REQUEST

Proposed Zoning: I-2(CD) LWPA (general industrial, conditional, Lake Wylie Protected Area)

Approximately 8.70 acres located on the west side of Rhyne Road, south of Mt. Holly Road, west of I-485.

SUMMARY OF PETITION	The petition proposes to allow an industrial park on a vacant parcel located in northwest Charlotte between Belmeade Drive and I-485.		
PROPERTY OWNER PETITIONER AGENT/REPRESENTATIVE	Artis Galbreath BSL Galbreath Inc. Anthony Fox, Parker Poe		
COMMUNITY MEETING	Meeting is required and has been held. Report available online. Number of people attending the Community Meeting: 3		
STAFF RECOMMENDATION	Staff recommends approval of this petition. <u>Plan Consistency</u> The petition is inconsistent with the land use recommendation as per the <i>Catawba Area Plan</i> for residential land uses up to 4 dwelling units per acre.		
	 <u>Rationale for Recommendation</u> While the subject property is planned for single family residential development, recent rezonings and development have resulted in more industrial and non-residential zoning districts and uses in the area. The proposed plan has provided a list of uses that eliminates potential compatibility issues with adj

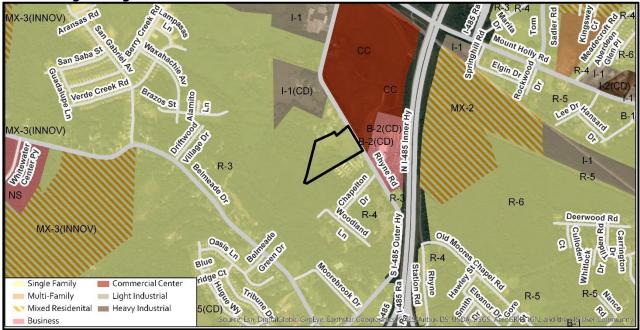
- Proposes 67-foot wide Class A buffers along the west and south property lines, and a Class B buffer ranging in width from 34.5 feet to 46 feet along the north property line. Notes buffer may be reduced or eliminated if adjacent properties are rezoned for non-residential uses.

- Proposes access onto Rhyne Road via new internal public street with 5-foot sidewalk and 4-foot planting strip.
- Notes all transportation improvements will be approved and constructed before the site's first building certificate of occupancy is issued.

- Proposes a 6-foot sidewalk and 8-foot planting strip along Rhyne Road.
- Identifies 30-foot post construction buffer and proposed possible stormwater facility.
